BRP-Powertrain GmbH & Co KG. Elektronisen yksikön lämpötila

Koskee: Kaikkia tyyppihyväksymättömiin ilma-aluksiin asennettuja Rotax 912A-, 912F-, 912S-, 914F-, 912UL-, 912ULS- ja 914UL-moottoreita.

Information release:
**CHECKING OF COMPONENT TEMPERATURE OF THE
ELECTRONIC MODULES FOR ROTAX 912 AND 914 (SERIES)**

Fig. 1
Electronic module

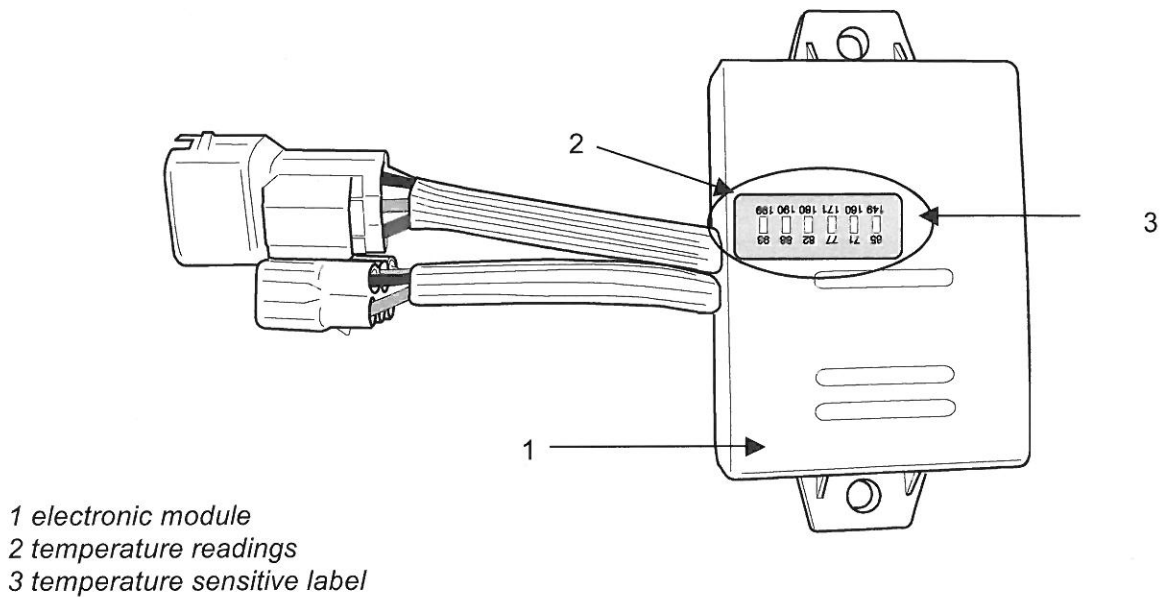
Step	Procedure
1	Check if the component temperature for the initial assembly of the modules was measured at the specified measuring location (2).
2	If the component temperature was measured at a different location as specified a new measurement is required.

NOTICE Both modules must be measured at the same location. See fig. (2).
The measurements must also be verified for "hot day conditions" and residual heat emission after stopping the engine.

- Limit of 80 °C (176 °F) has been exceeded.

NOTICE Electronic modules that have been overheated in operation (i.e. the maximum component temperature has been exceeded) must be replaced. It may be necessary to replace both electronic modules.
Any replacement has to be conducted in accordance with the relevant Maintenance Manual.

Step	Procedure
1	The corresponding prototype has to be modified in such a way as to ensure that the limit for the component temperature is not exceeded.
2	Information to the affected owners about the relevant measures.
